ADDENDUM NO. 2

Rochester City School District

Dr. Walter Cooper, School #10

February 28th, 2018

H1302 DRAWING NOTES

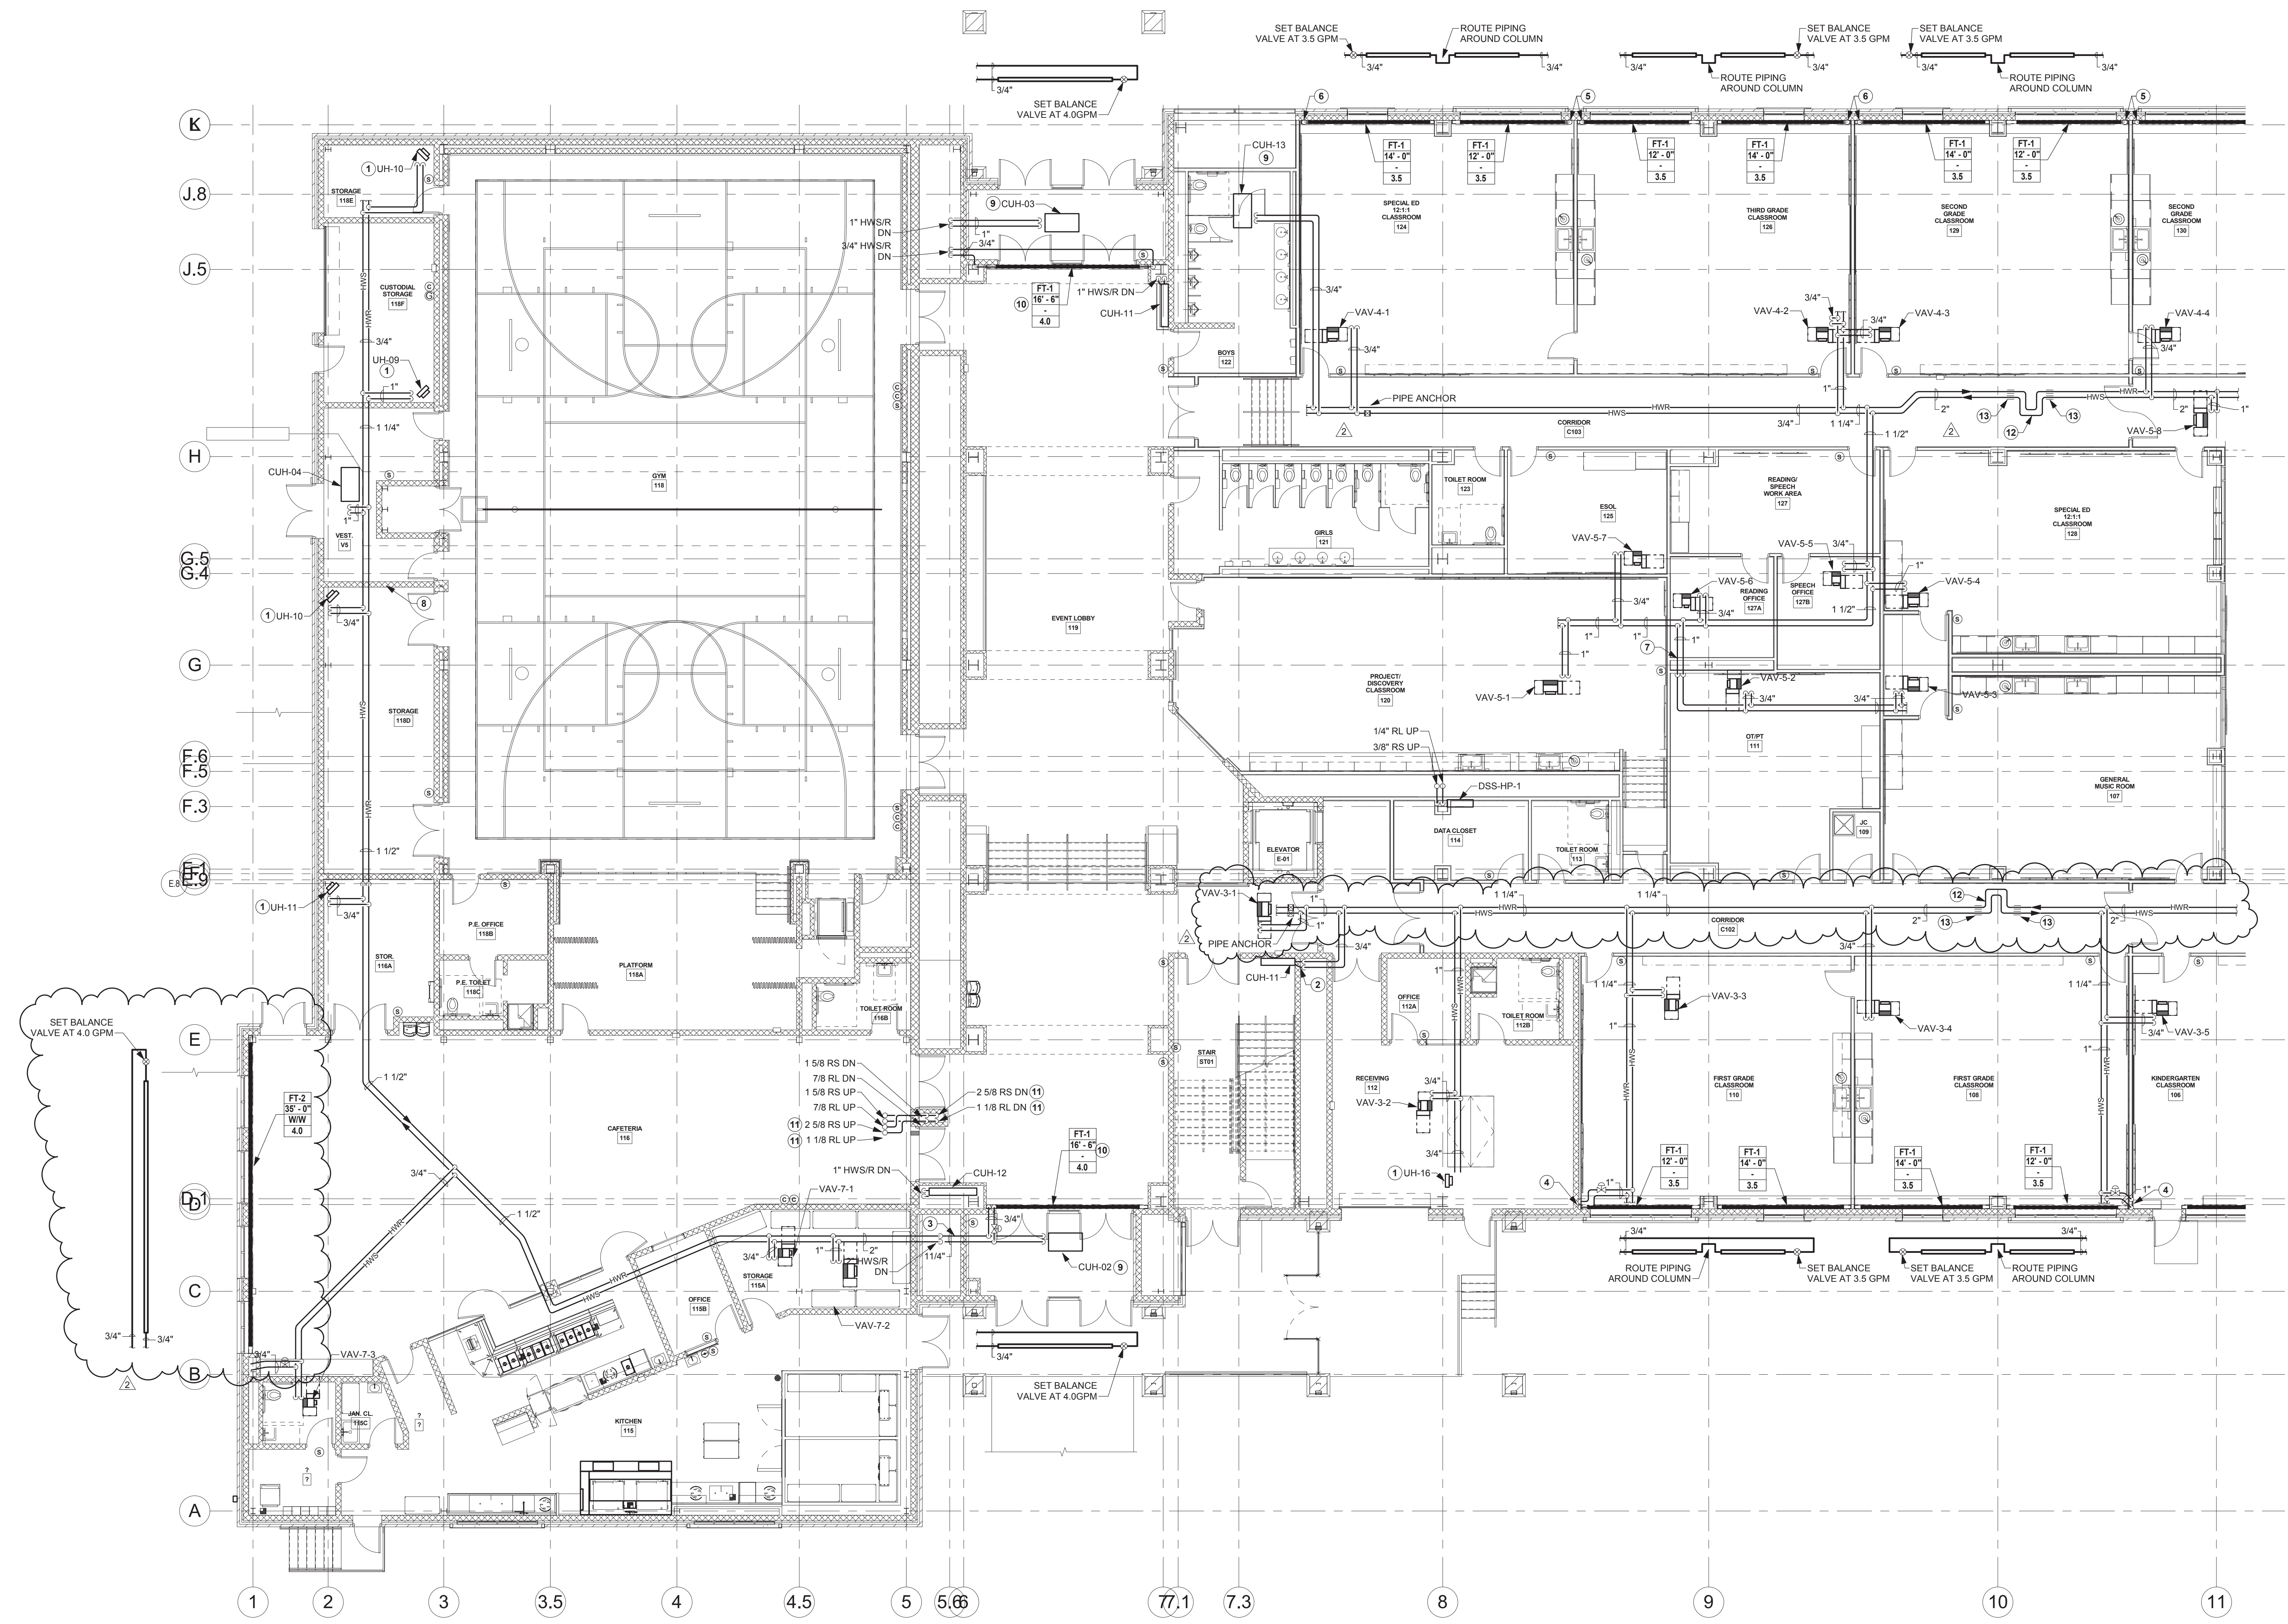
- Item AD2-38 **REPLACE** drawing in its entirety with attached “H1302 – PARTIAL FIRST FLOOR PLAN – HVAC PIPING.” Add piping anchors, guides and expansion loop to heating water piping. Revise cafeteria fin tube as shown. Revise HWS/R piping routing in corridor C102.

H1304

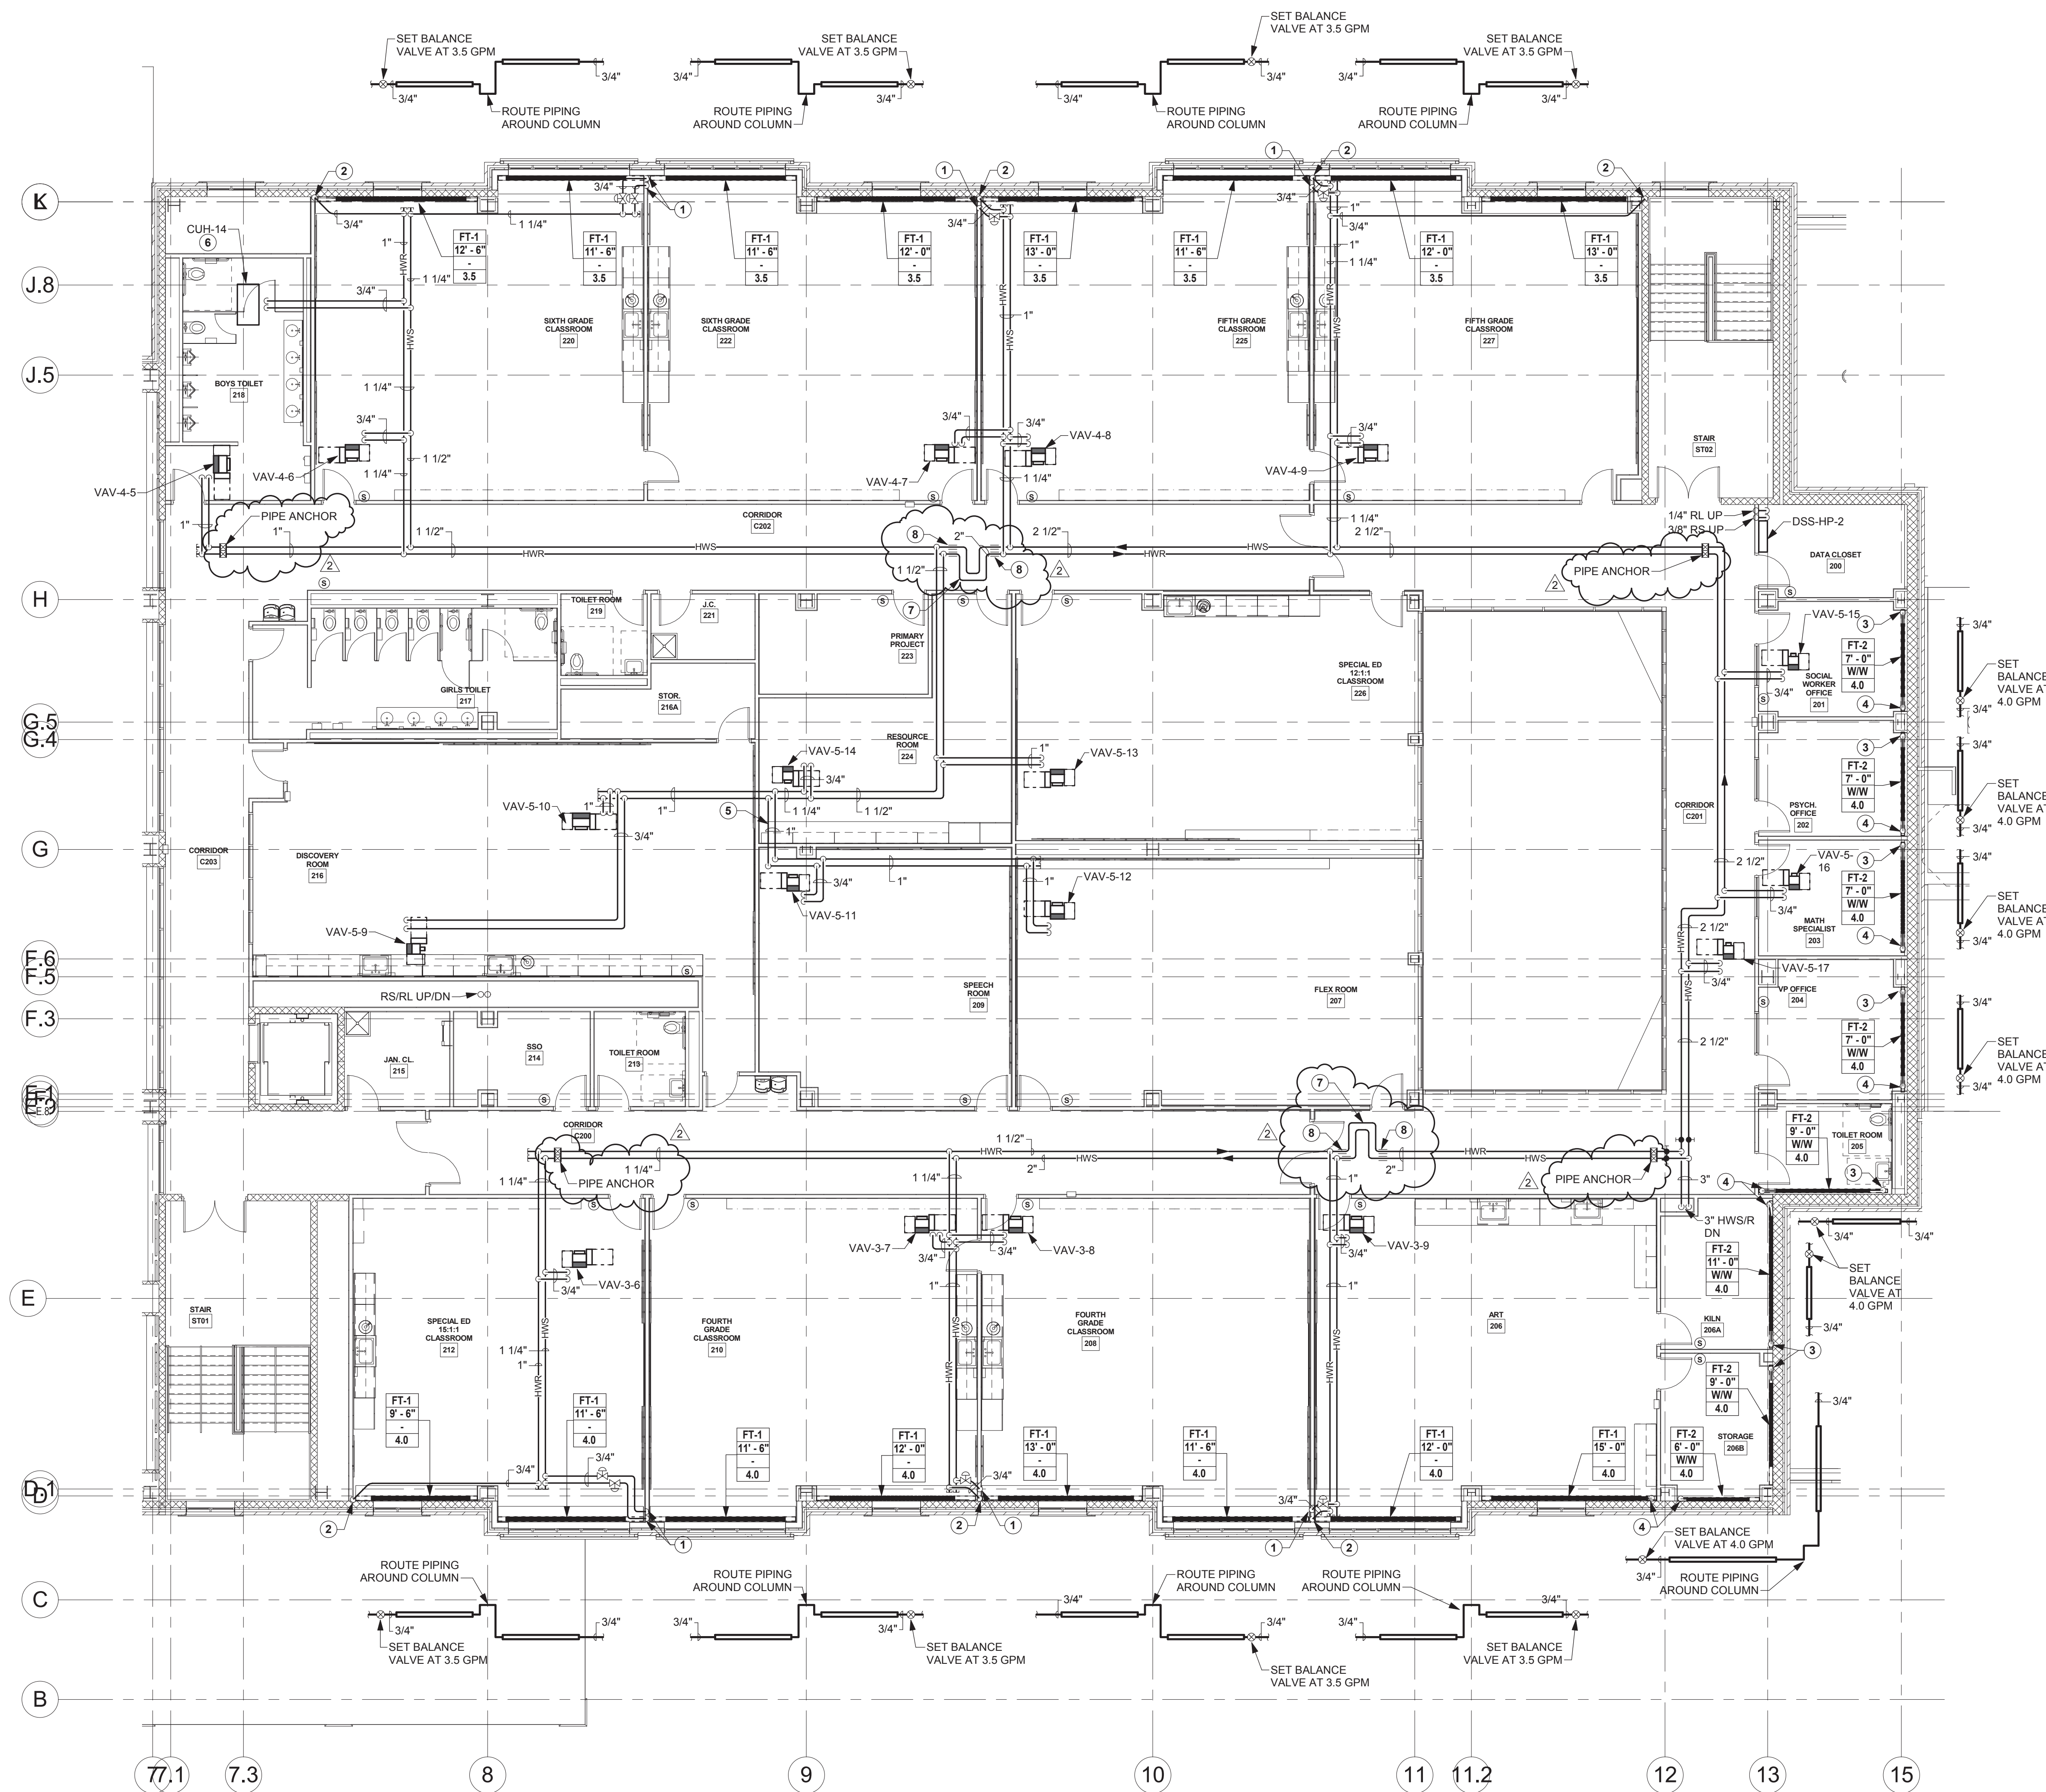
Item AD2-40 **REPLACE** drawing in its entirety with attached "H1304 - PARTIAL SECOND FLOOR PLAN - HVAC PIPING." Add piping anchors, guides and expansion loop to heating water piping.

AD2-QF001

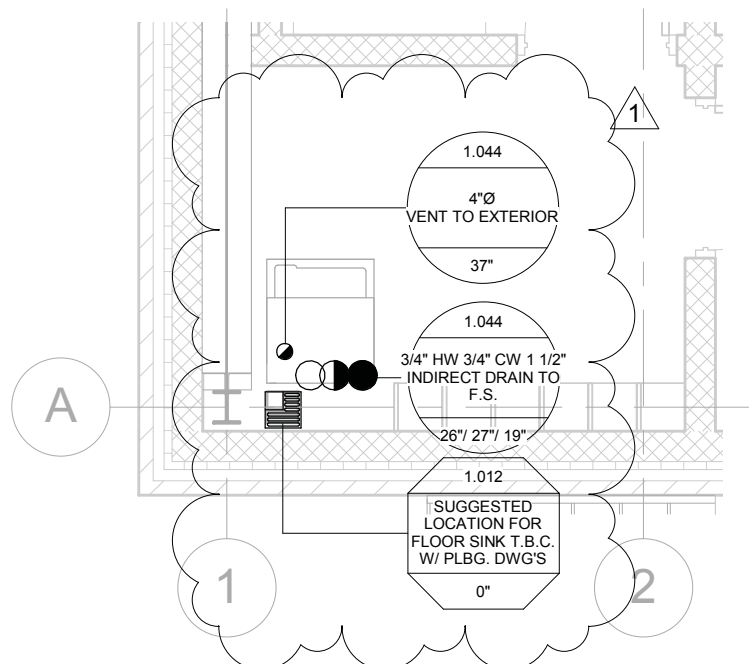
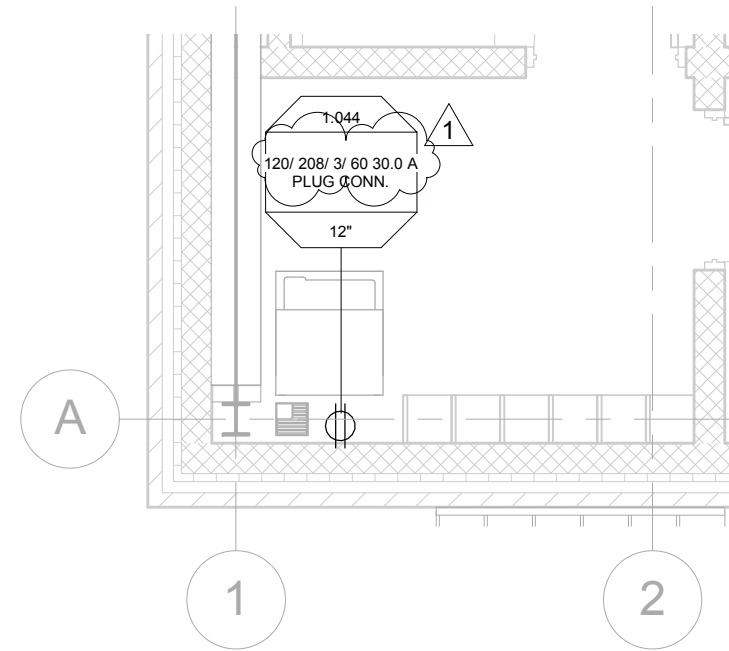
Item AD2-25 **ADD** attached sketch “AD2-QF001 – FIRST FLOOR – CONNECTION POINT PLANS.” Add plumbing, mechanical and electrical connections for laundry washer and dryer.

AD2-QF002

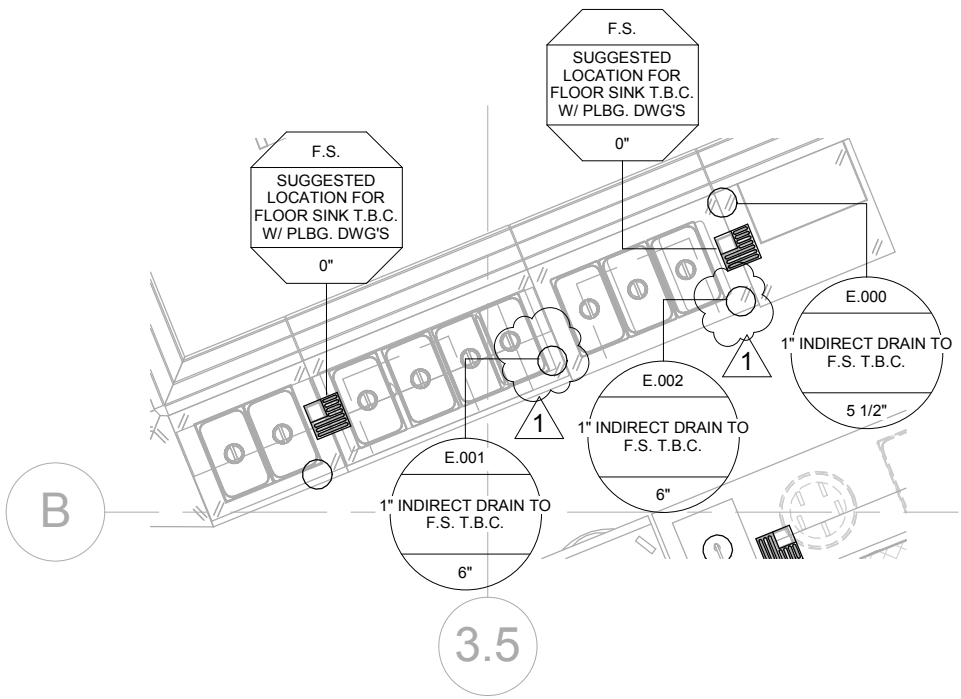
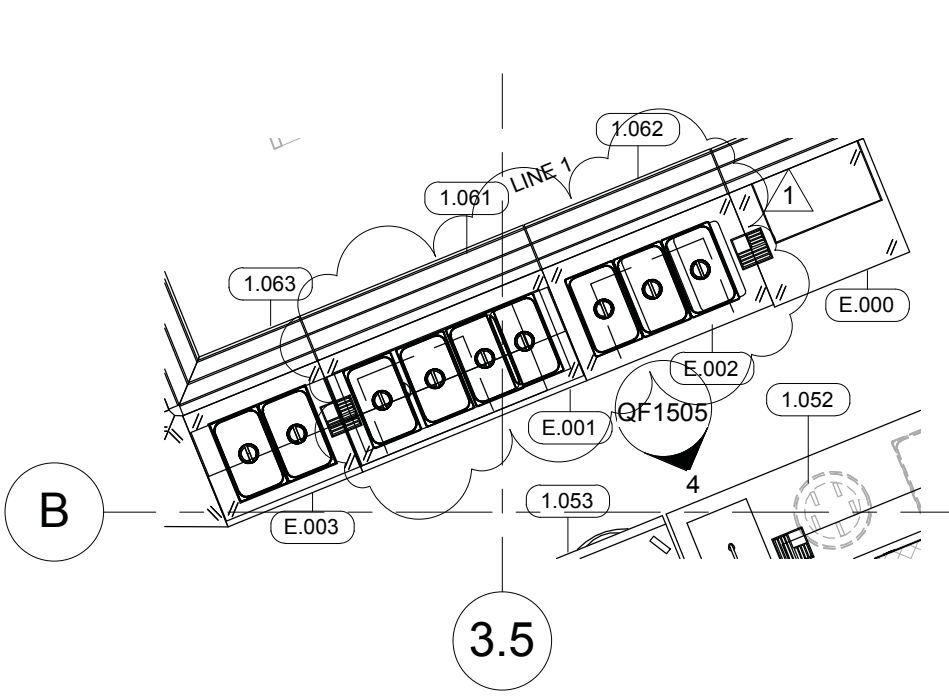
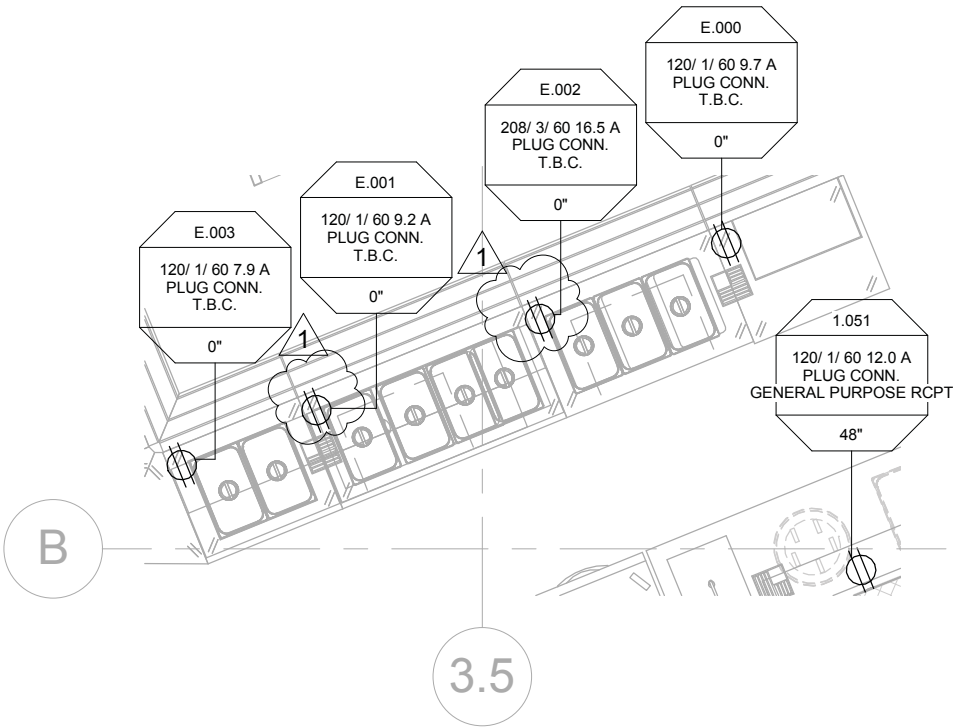
Item AD2-26 **ADD** attached sketch “AD2-QF002 – FIRST FLOOR – CONNECTION POINT PLANS.” Add plumbing, mechanical and electrical connections for food service equipment.

AD2-P002

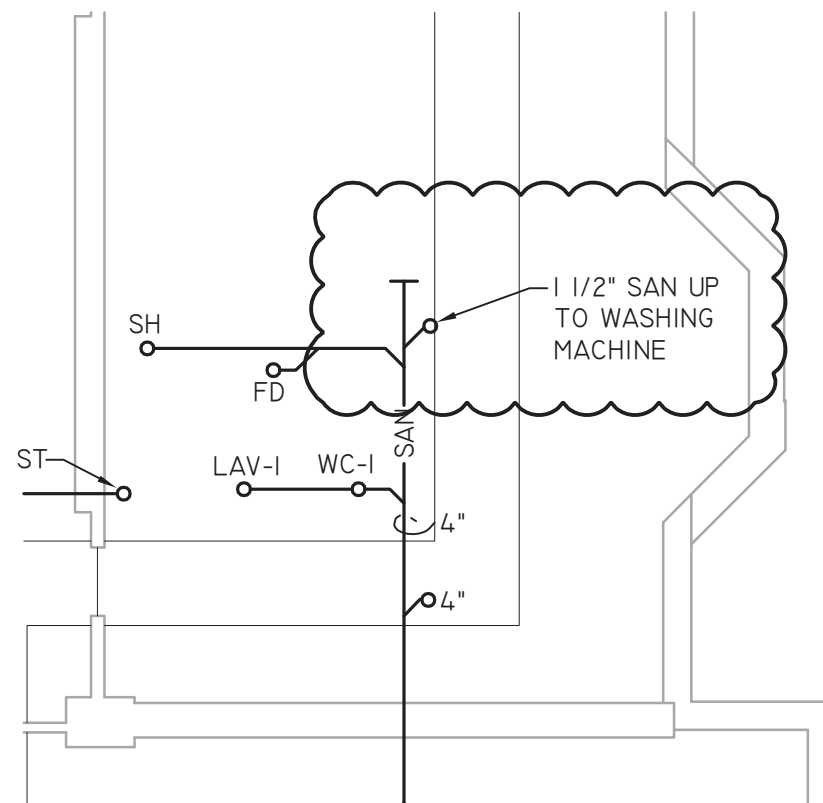
Item AD2-27 **ADD** attached sketch “AD2-PO02 – REVISION TO SANITARY.” Add piping for laundry washer.
